# Text Contribution for P802.1Qdq

24<sup>th</sup> of September 2021

# What do we propose to update?

# Proposal of New Figure Y-1

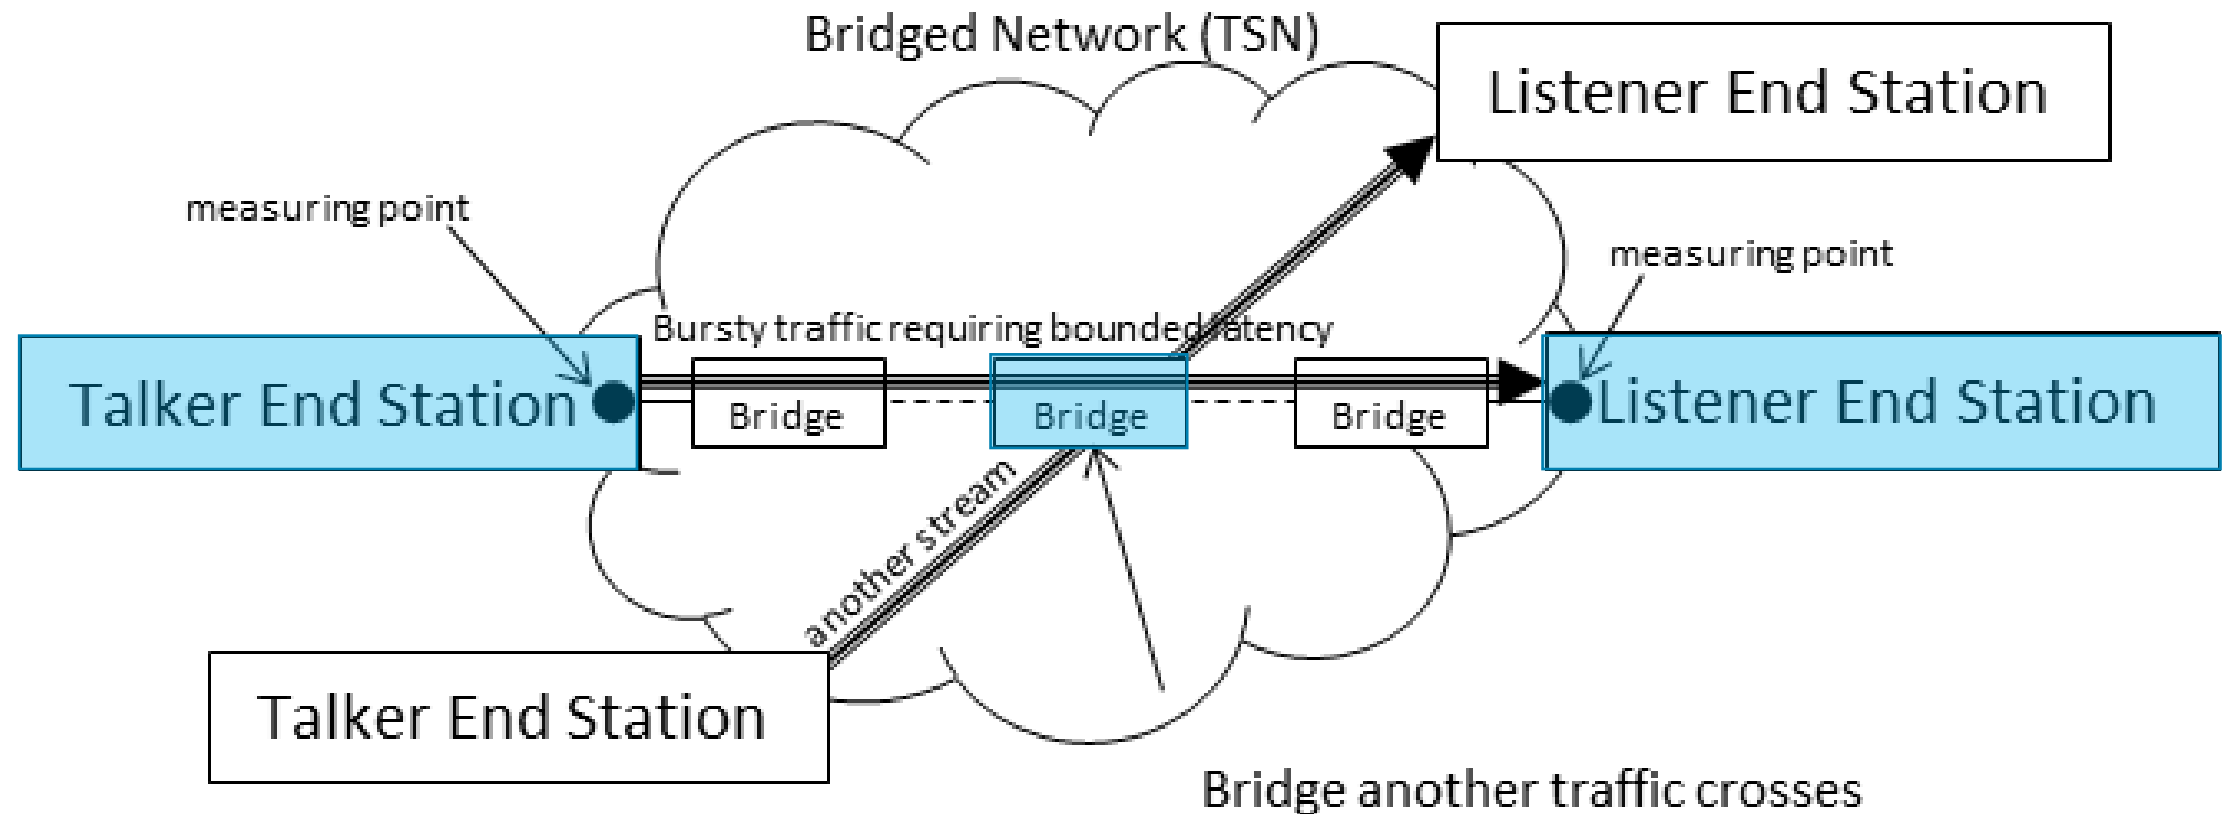
# 1. Review of Figure Y-1

- There are many contents mixed in a one figure.
- Relation between “Application” and “Talker” is illustrated in Figure Y-1’, so it is not required here.

Remove because Figure Y-1’ also explains this

- P802.1Q clause 3 defines Talker as “The end station that is the source or producer of a stream.” Nevertheless, we use “Talker End Station” in this figure to clarify it is an end station, not a bridge.
- We focus on latency between measuring points in Talker and Listener.
